Model DMM7510 7½ Digit Graphical Multimeter

Version 1.6.3d Firmware Release Notes

GENERAL Models affected:

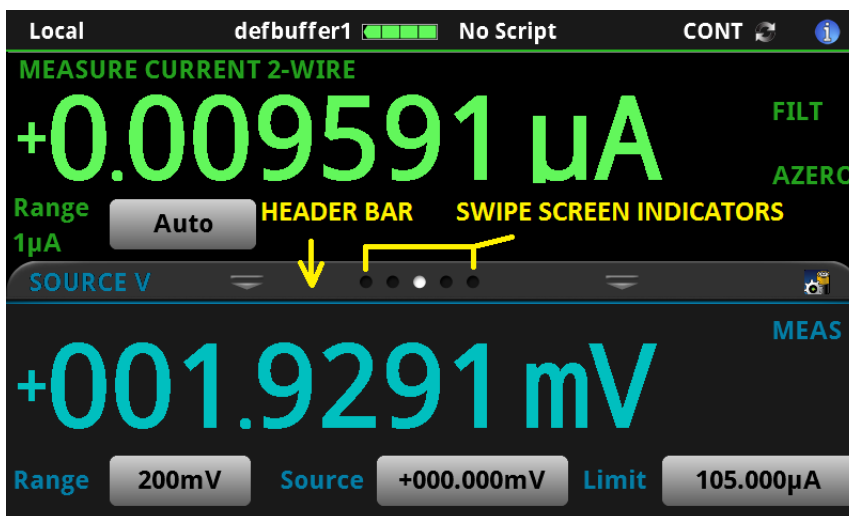
A number of improvements have been made to the overall Graphical User Interface as follows:

1. Screen Colors: All screen colors have been modified for better contrast and easier readability.
2. Pinch-to-Zoom Performance: Throughout the user interface, the “Pinch-to-zoom” touch screen motion has been improved and is more responsive.

3. Improve Swiping:
 - a. The swipe user interface gesturing has been dramatically improved and is more responsive.
 - b. Added Vertical Swiping in various screens in the GUI.
